Enclosed for your review are two copies of the Final Construction Completion Report for the Remedial Action at Solid Waste Management Unit 101—Sewage Lagoons Cannon Air Force Base, New Mexico, dated Mar 05.

**Draft Construction Completion Report for the Closure of SWMU 101–Sewage Lagoons
Cannon Air Force Base, New Mexico
October 2004**

The New Mexico Environment Department (NMED) has completed its review of Cannon Air Force Base's (CAFB's) 2005 "*Final Construction Completion Report Remedial Action*". NMED also reviewed CAFB's April 2001 *Revised Final Corrective Measures Study Report SWMU 101-Sewage Lagoons*, and the February 2003 *Final Work Plan for the closure of SWMU 101-Sewage Lagoons*". Before this report can be approved CAFB must supply additional information and clarification as follows.

Figure 3-1

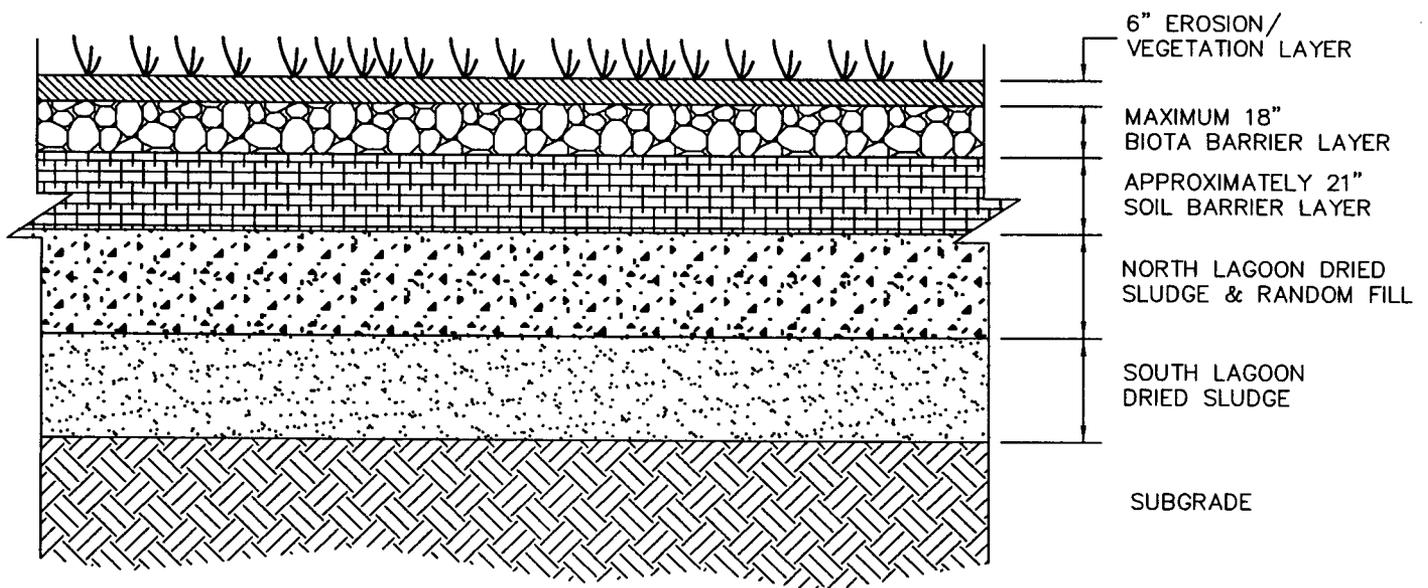
1.	General	Include figure showing typical cross section of cover system for reference with paragraphs 3.1.4 – 3.1.7.	The text was revised and a figure was added to provide the general schematic cross-section of the cover system as requested.
